REPORT TITLE	Reconfiguring a Lot – Impact – Five (5) Lots into 71 Lots located at 37-59 Harrow Street and 2-22 Devonshire Street, DRAYTON QLD 4350
AUTHOR	Planning Officer (James Leader)
Application No.	RAL/2025/4731

APPROVED Application No. RAL/2025/4731 for a Development Permit for Reconfiguring a Lot – Impact – Five (5) into 71 Lots, pursuant to the provisions of Section 60 of the *Planning Act 2016* and subject to the conditions listed below.

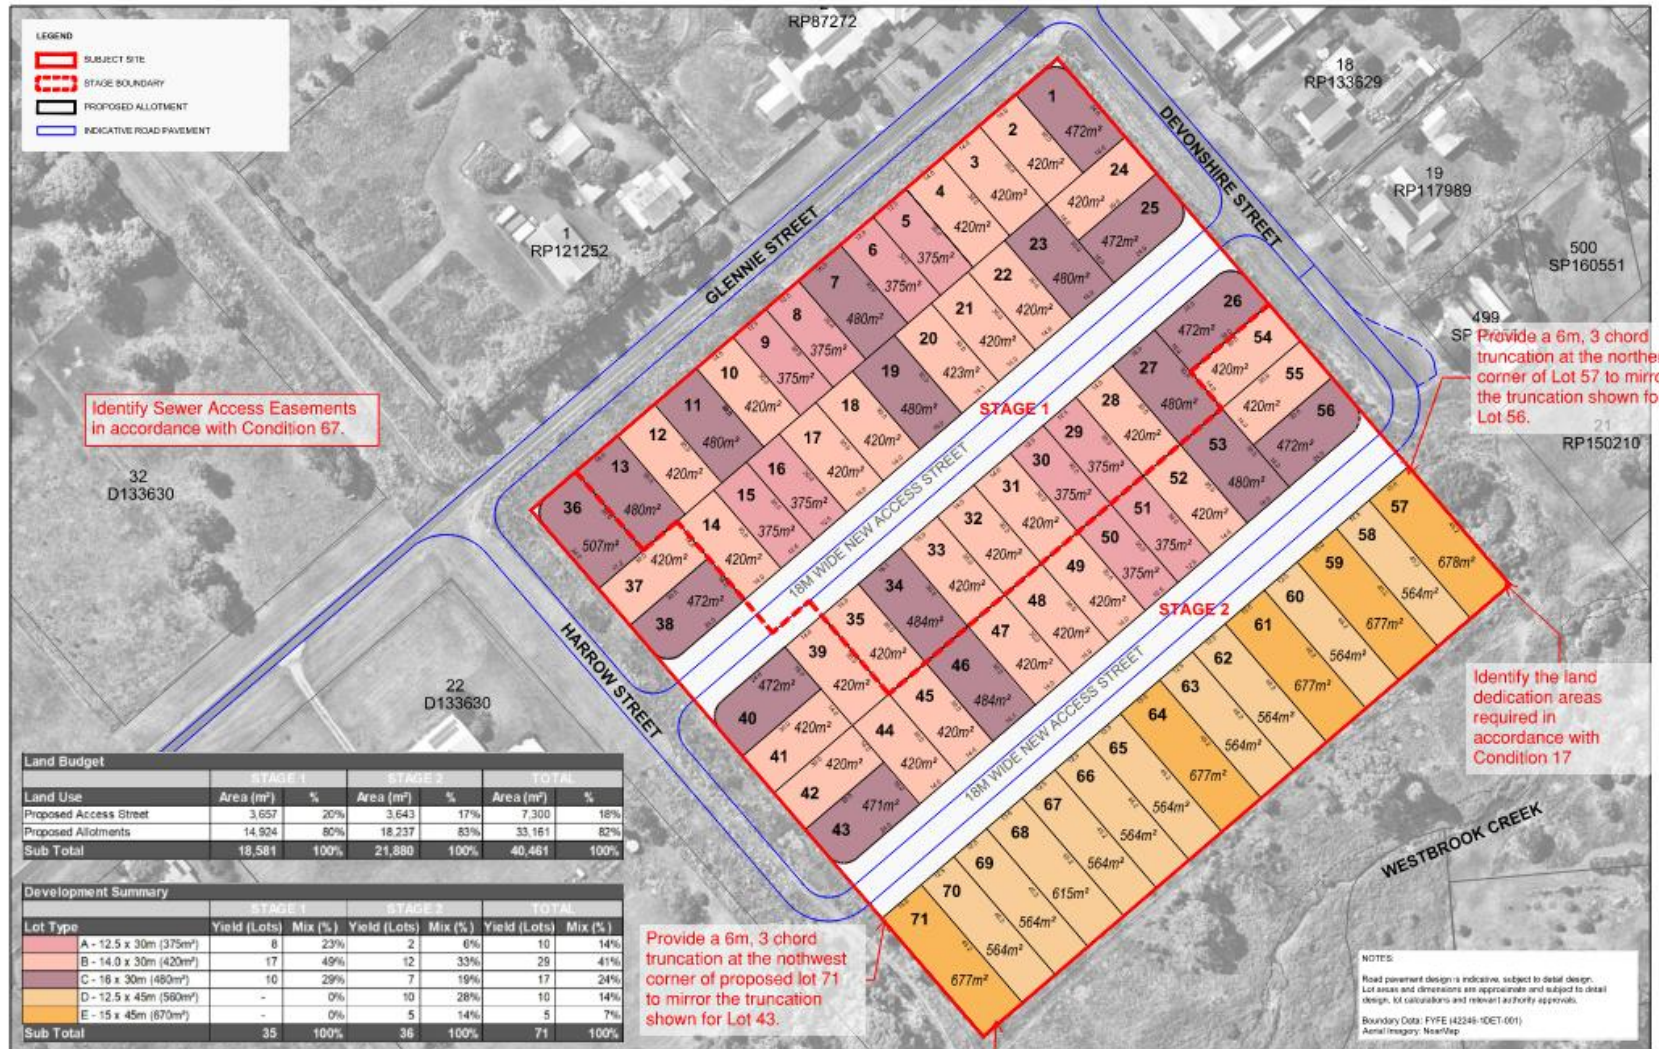
Identify Sewer Access Easements in accordance with Condition 67.

Provide a 6m, 3 chord truncation at the northern corner of Lot 57 to mirror the truncation shown for Lot 56.
